CONTRACT CHANGE ORDER NO. ____
SHEET ___ OF ___

MARK	DATE	DESCRIPTIONS	BY	CH'D	CCO#
2	04/05/12	SUSPENSION SYSTEM SHIMS	GB	MN	240
1	04/16/07	CABLE SYSTEM	GB	DT	37

SAN FRANCISCO OAKLAND BAY BRIDGE
EAST SPAN SEISMIC SAFETY PROJECT
SELF-ANCHORED SUSPENSION BRIDGE
(SUPERSTRUCTURE & TOWER)

SLOTTED SHIM DETAIL
1:5

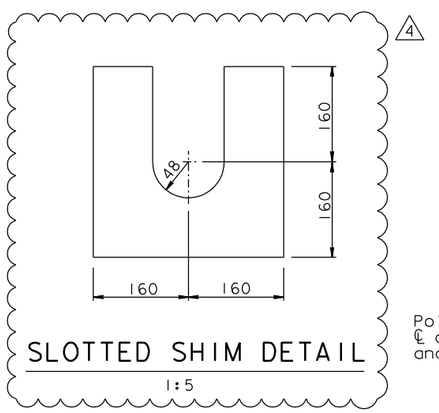
MARK	DATE	DESCRIPTIONS	BY	CH'D	CCO#
4	04/05/12	SUSPENSION SYSTEM SHIMS	GB	MN	240
3	02/20/09	SUSPENDER BRACKETS	GB	DT	104
2	08/15/08	CABLE ELECTRICAL	GB	DT	72
1	04/16/07	CABLE SYSTEM	GB	DT	37

1. Threaded rod may be used for erection. After installation of suspender socket, ends shall be sealed with 90 Dia A307 bolts.
2. For details not shown, see "Suspender Bracket Details No.1" through "Suspender Bracket Details No.3" sheets.
3. For split collar details, see "Suspender Bracket Details No.5" sheet.
4. The Contractor shall consider variation in roadway grade in his details.
5. For cable band details, see "Cable Band Details" and "Cable Handrope Details" sheets.
6. For suspender brackets at PP 108 and PP 110, see "Suspender Bracket Details No.8" and "Suspender Bracket Details No.9" sheets.
7. For shim stack heights, see "Suspender Bracket Details No.10" sheet. 4

WEST DEVIATION SADDLE DETAILS NO. 6

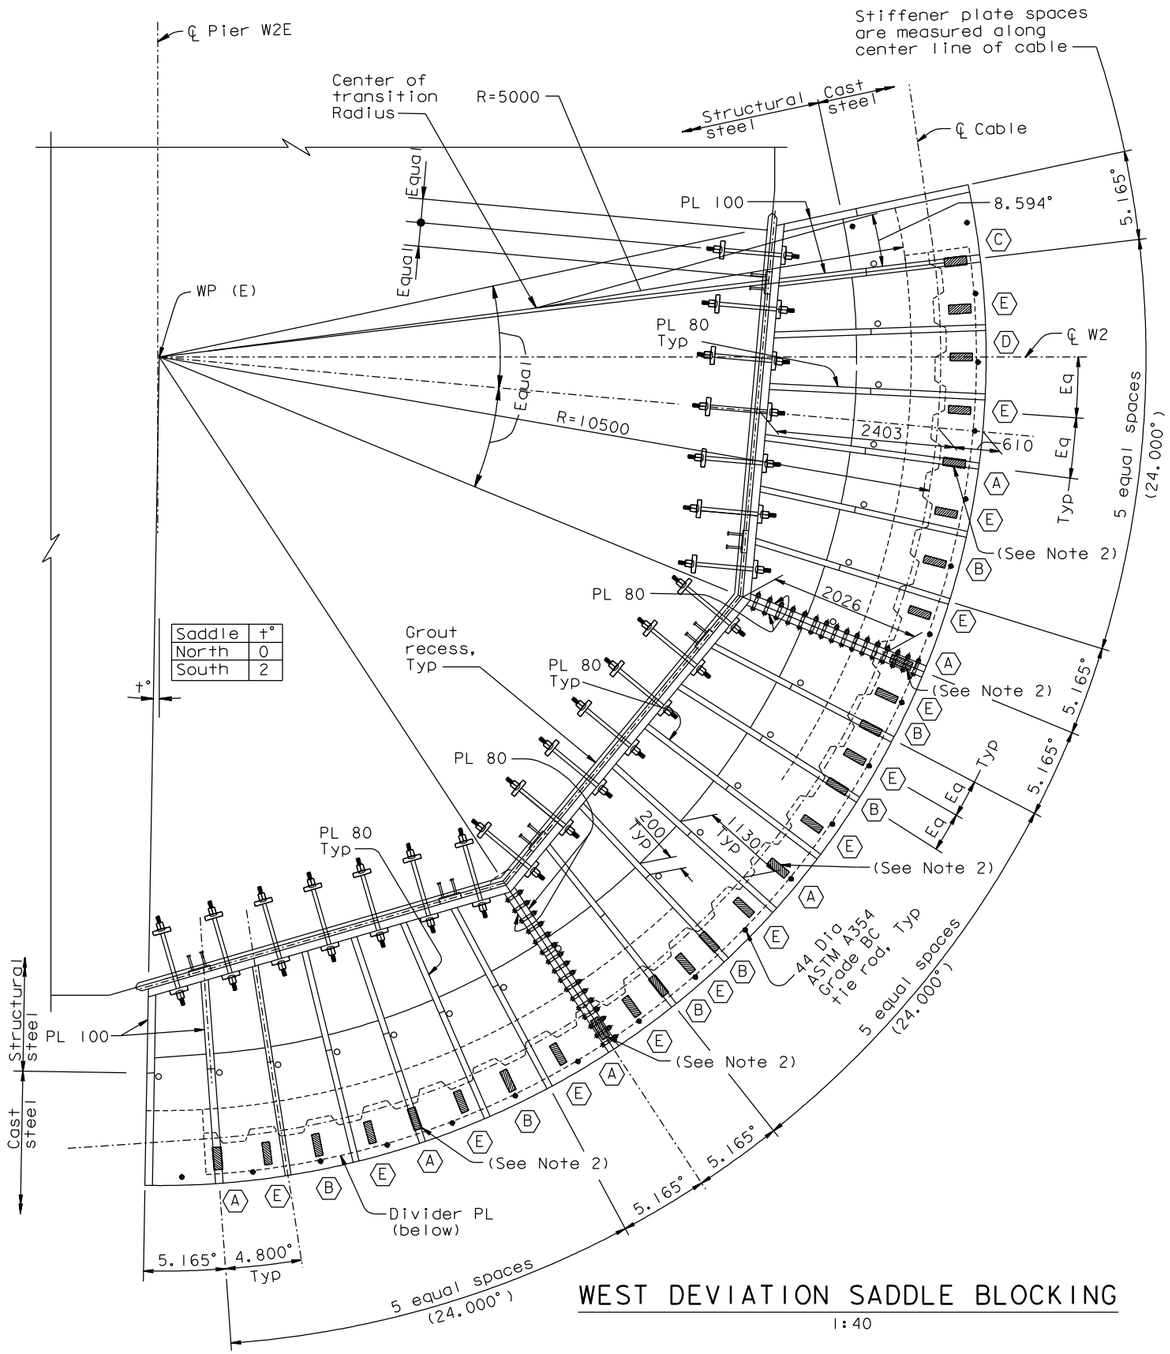
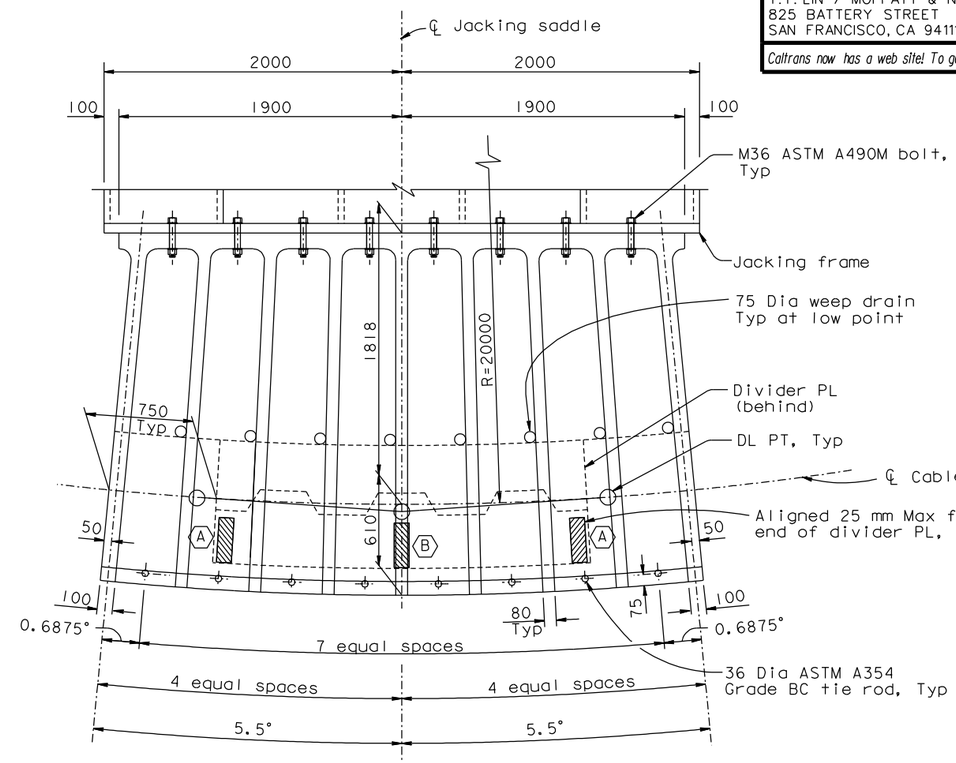
MARK	DATE	DESCRIPTIONS	BY	CH'D	CCO#
0	05/09/12	SADDLE BLOCKING	GB	MN	240

1. For blocking types and details, see "West Deviation Saddle Details No. 7" sheet.
2. Blocking at these locations shall straddle the as-built divider plate radial joint.

WEST DEVIATION SADDLE DETAILS NO. 7

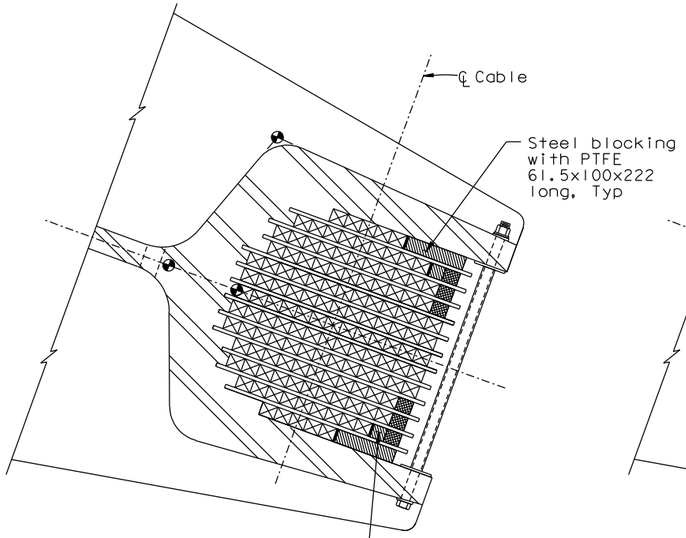
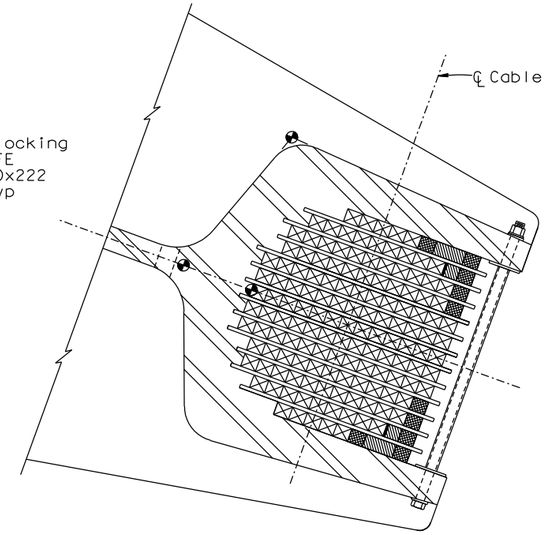
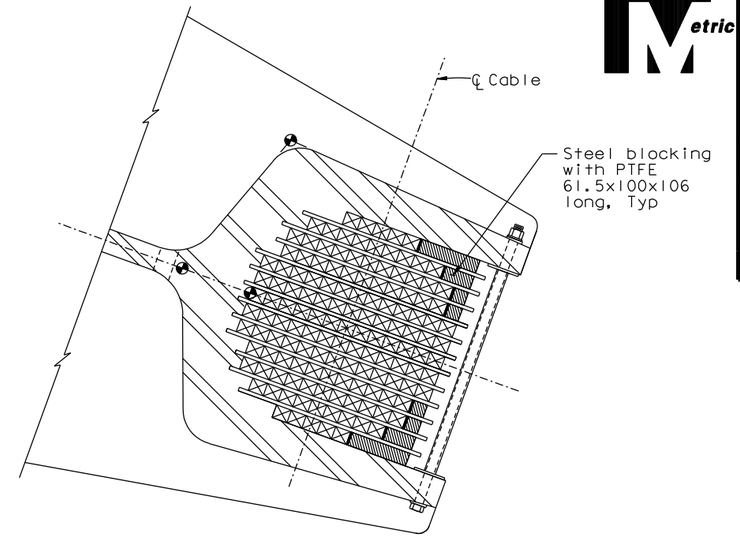
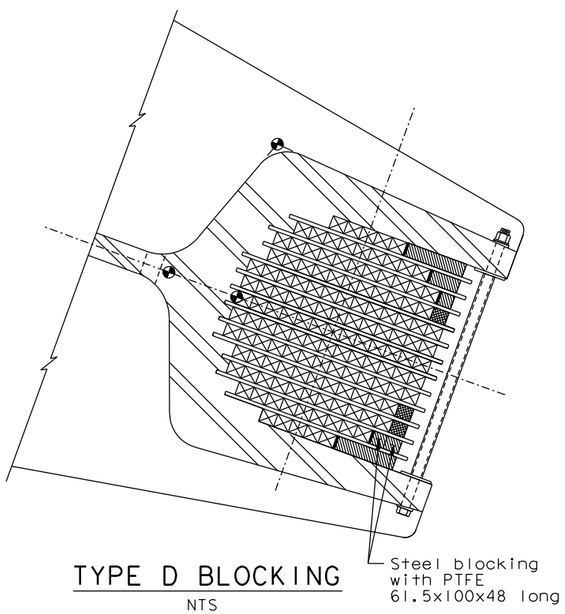
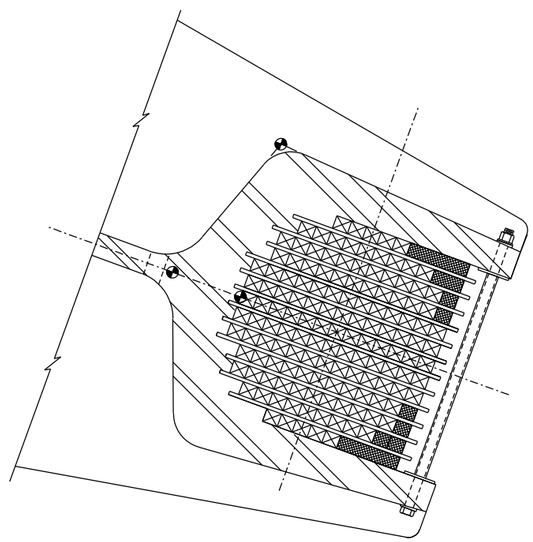
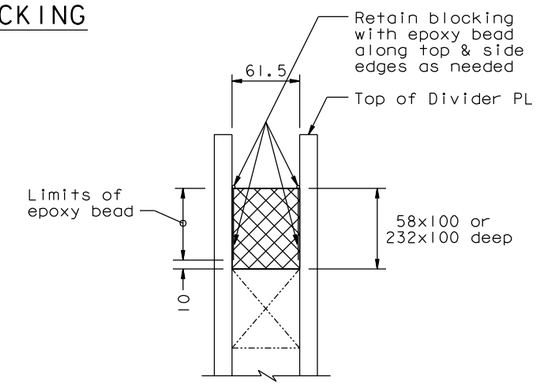
MARK	DATE	DESCRIPTIONS	BY	CH'D	CCO#
0	05/07/12	SADDLE BLOCKING	GB	MN	240

1. Steel blocking fabricated for Tower saddle shall be used for West deviation and jacking saddles.
2. At the Contractor's option, hardwood shims and blocking may be used in lieu of UHMWP.
3. The completed blocking at each location is fabricated to fit tightly. Should tight fit not be achieved, the Contractor shall inform the Engineer for evaluation.

TOWER SADDLE DETAILS NO. 4

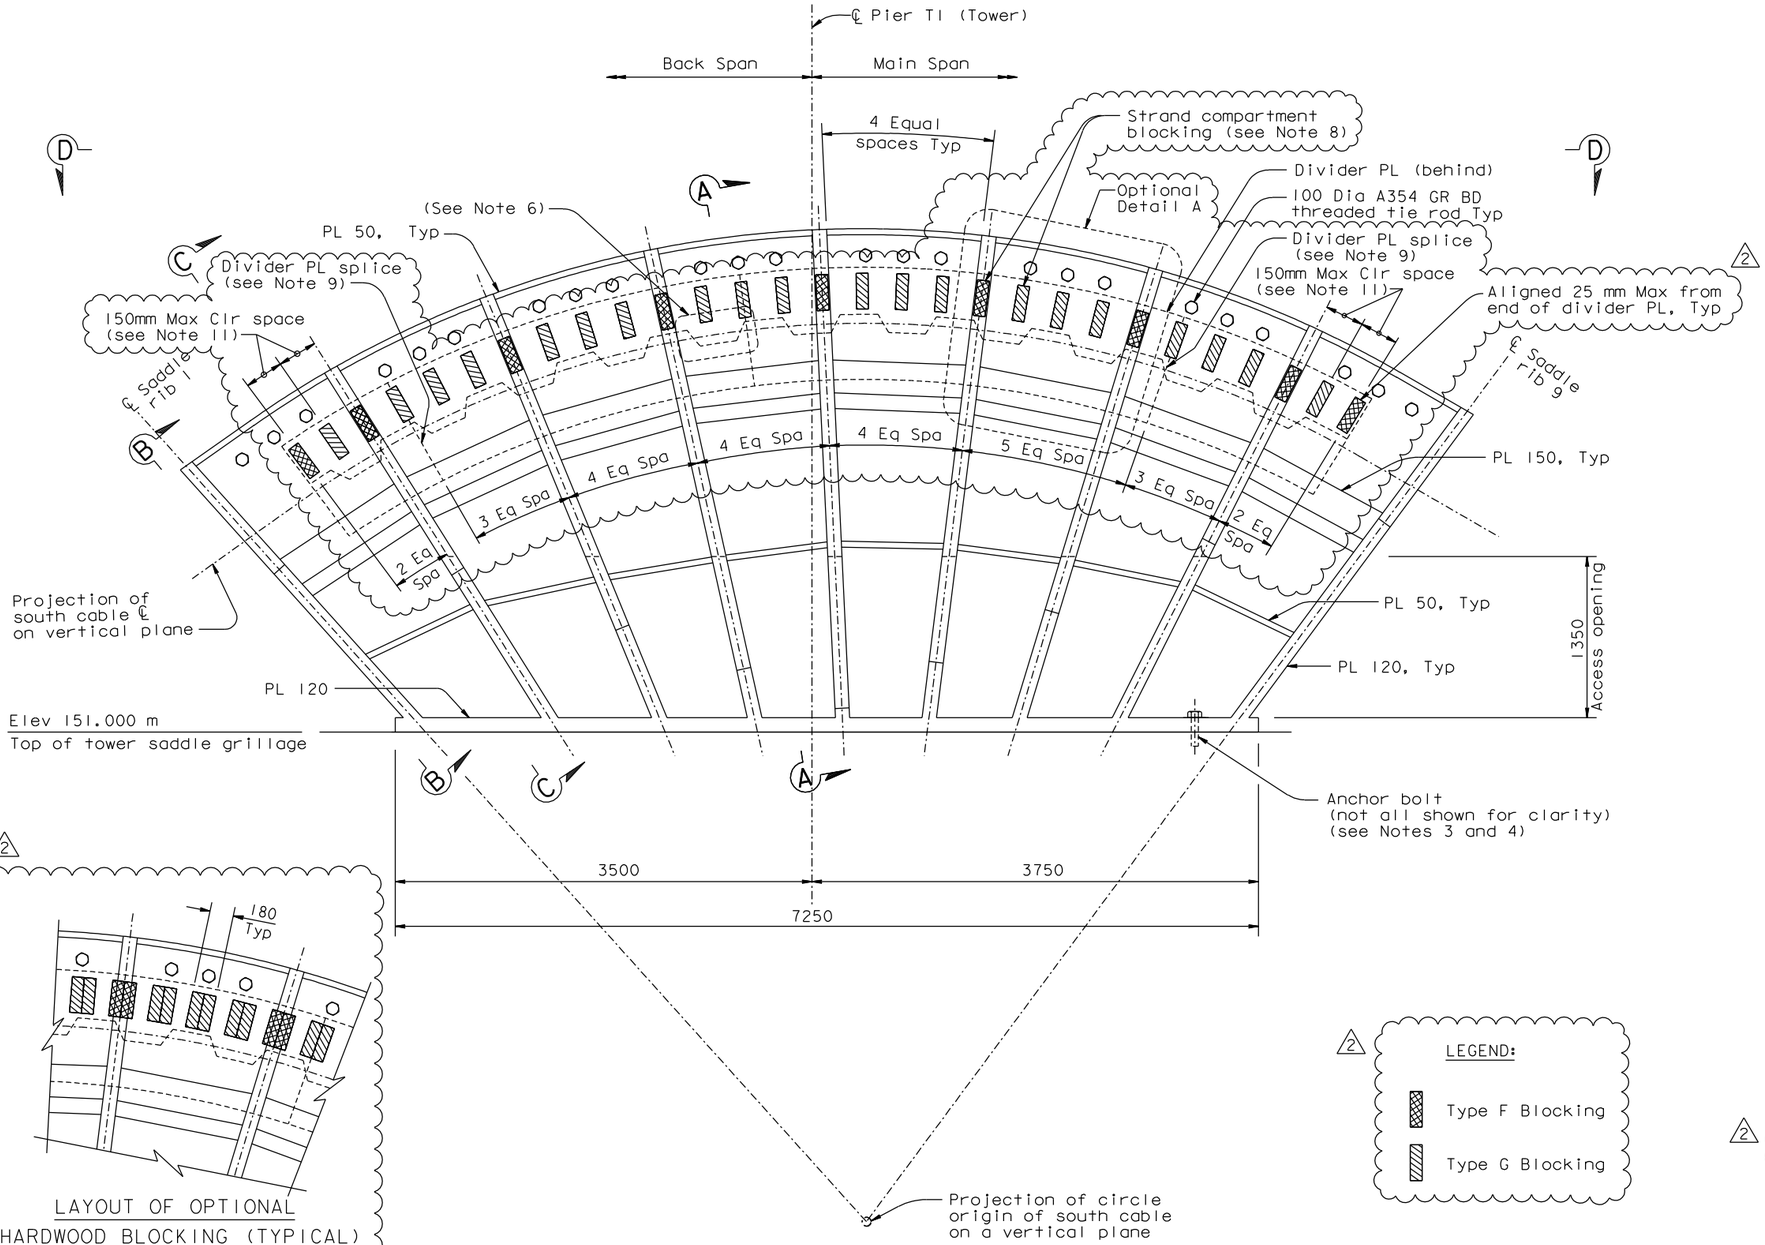
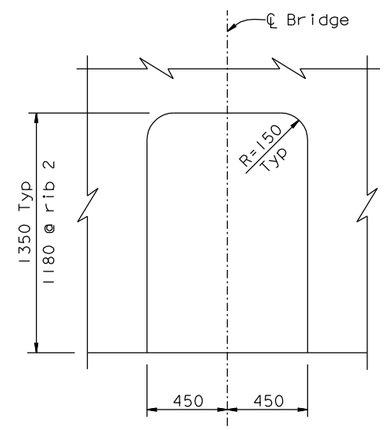
MARK	DATE	DESCRIPTIONS	BY	CH'D	CCO#
2	05/09/12	SADDLE BLOCKING	GB	MN	240
1	10/31/08	TOWER HEAD DETAILS	MN	GB	93

8. Contractor shall fabricate and install new blocking. For layout, see "Tower Saddle Details No.5B" sheet. For blocking details, see "Tower Saddle Details No.6" sheet.

9. The blocking shall be placed such that it straddles the divider plate spacing joint.
10. At the Contractor's option, hardwood blocking may be installed and left in place through load transfer. Hardwood blocking shall be installed in widths of 180 mm, and cut on site to fit tightly at each blocking location. After load transfer, hardwood blocking shall be left in place or replaced as directed by the Engineer.

11. Where clear distance adjacent to G blocking exceeds 150 mm, the Contractor shall install additional 90 mm wide Type G blocking in the space.

TOWER SADDLE DETAILS NO. 5B

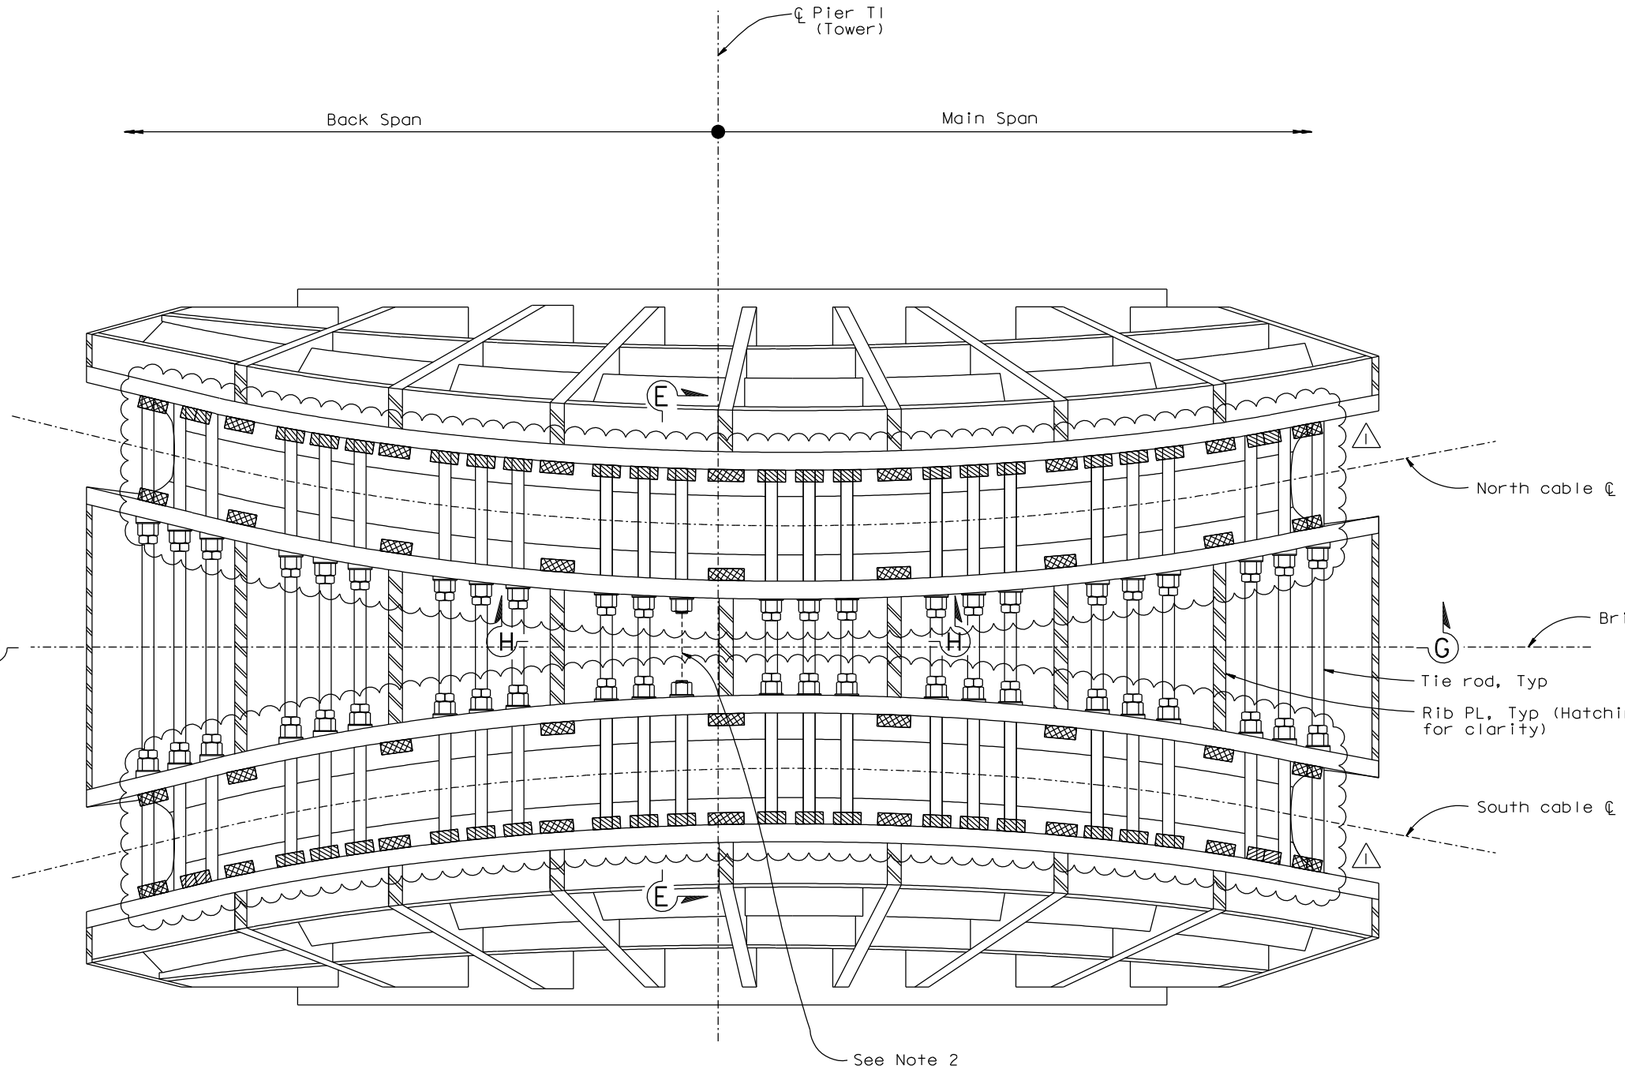
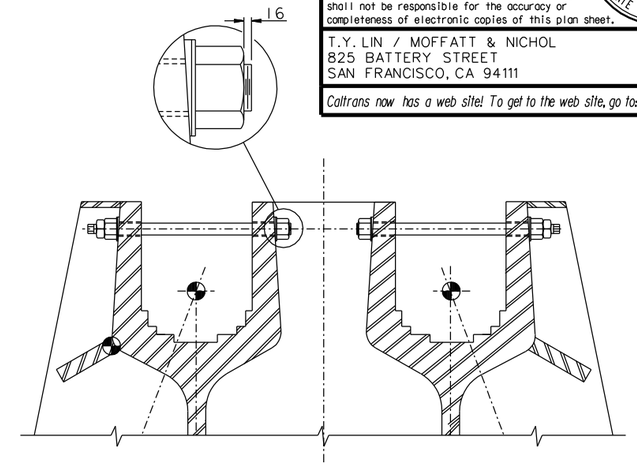
MARK	DATE	DESCRIPTIONS	BY	CH'D	CCO#
1	05/07/12	SADDLE BLOCKING	GB	MN	240
0	10/31/08	TOWER HEAD DETAILS	NV	MN	93

1. For Section G-G, see "Tower Access Details No.23" sheet. For Section H-H, see "Tower Saddle Details No.5A" sheet.
2. Tie rod is discontinuous between saddle troughs at this location only.
3. For blocking, see "Tower Saddle Details No.6" sheet.

TOWER SADDLE DETAILS NO.6

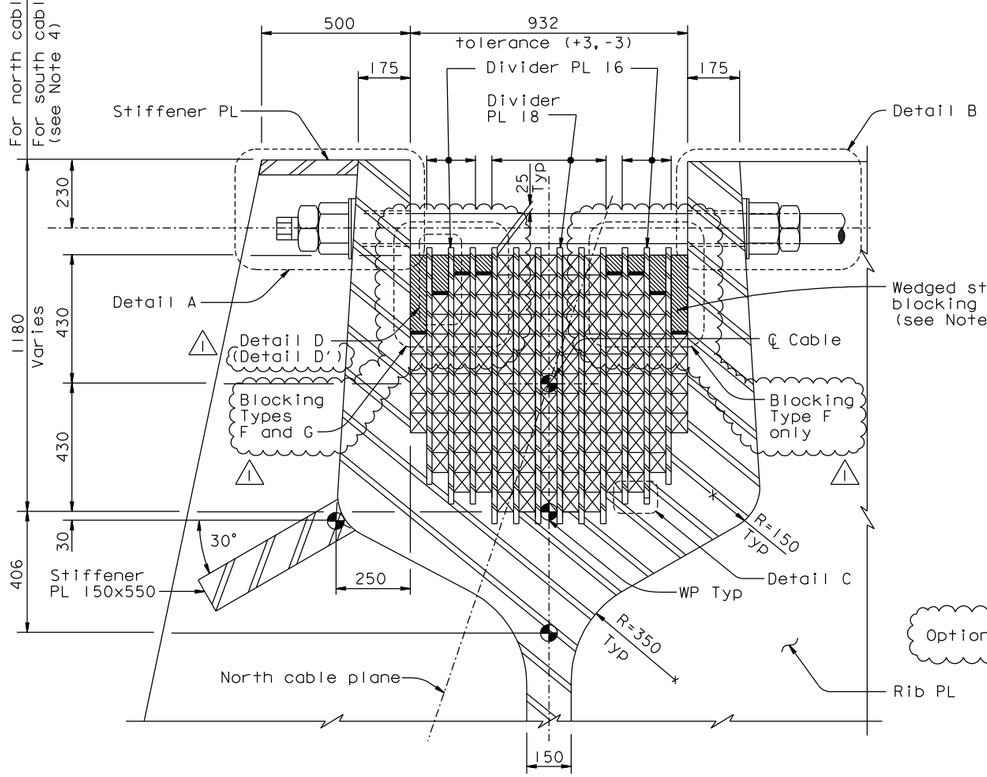
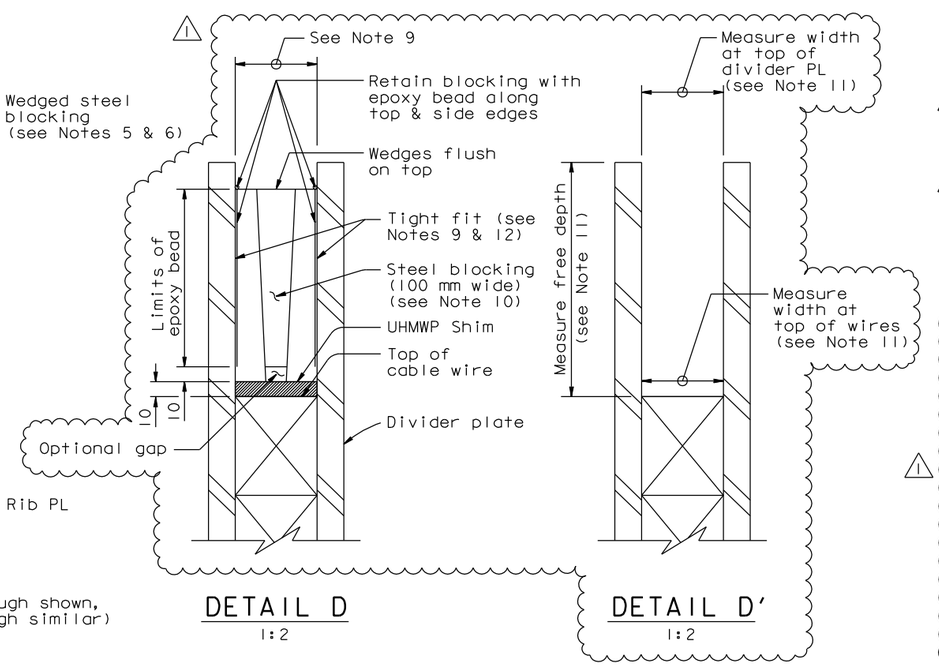
MARK	DATE	DESCRIPTIONS	BY	CH'D	CCO#
1	05/07/12	SADDLE BLOCKING	GB	MN	240

8. The tapered faces of the divider plates shall be placed facing the centerline of the bridge.
9. Prior to fabrication of new blocking, the Contractor shall measure as-built compartment widths. The blocking shall be fabricated to fit tightly at top and bottom within the as-built compartment dimensions.

10. At the Contractor's option, the steel blocking may be fabricated in several pieces. The taper of any piece shall not exceed 1:20. Provide adhesive between surfaces of blocking pieces.

11. Tower Saddle survey (see Detail D'):
    - Measure compartment width at top & bottom
    - Measure compartment depth
    - Measure at each blocking sections Type F & G

- At each section, measure all 13 compartments
12. The completed blocking at each location is fabricated to fit tightly. Should tight fit not be achieved, the Contractor shall inform the Engineer for evaluation.
